**Water Pollution Control Plant
Energy Storage System Installation
Project Review**

- City of San Leandro, August 2020 -

The City of San Leandro requested from DERNetSoft a third party evaluation of the energy storage system (ESS) proposal in consideration for the Water Pollution Control Plant (WPCP). The proposal was originally compiled and presented by Climatec and includes several energy efficiencies measures.

Figure 1 - Energport Energy Storage System architecture

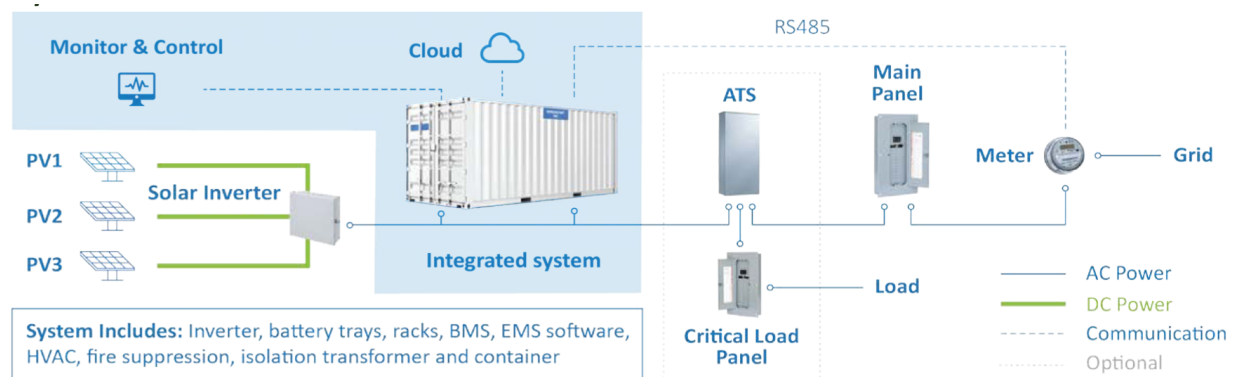
In the Climatec package and in the product description, we were not able to find the following information:

- Other protocol support for utility grid service provisioning (i.e. DNP3, 2030.5)
